Lead Local Flood Authority

RE: DM/25/1853 - West Hoathly Brickworks, Hamsey Road, Sharpthorne, East Grinstead, West Sussex, RH19 4PB

This application is for Discharge of Conditions 2 (Materials Schedule), 6 (Site Levels) and 7 (Drainage) relating to DM/23/0827.

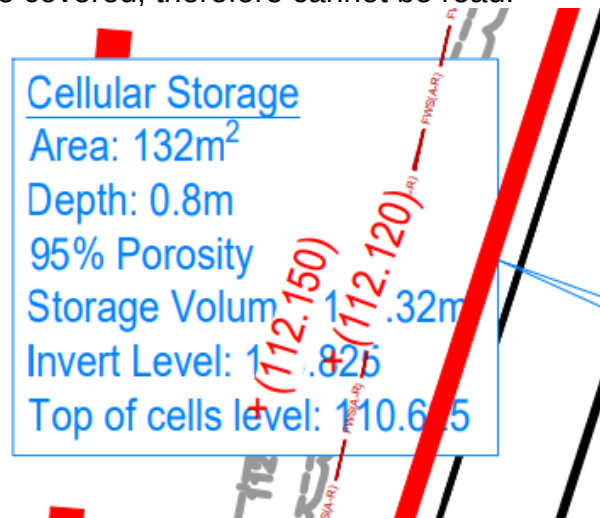
- We have concerns that there have been alterations to the drainage strategy approved at full planning stage, but these changes have not been backed up by relevant calculations and supporting documents. The calculations must follow up to date parameters (FEH2022, Cv value 1, MADD factor/additional storage 0).
- Previously there were rain gardens proposed, however these have been removed from the drainage layout in the DoC.
- Some of the labels are covered, therefore cannot be read:
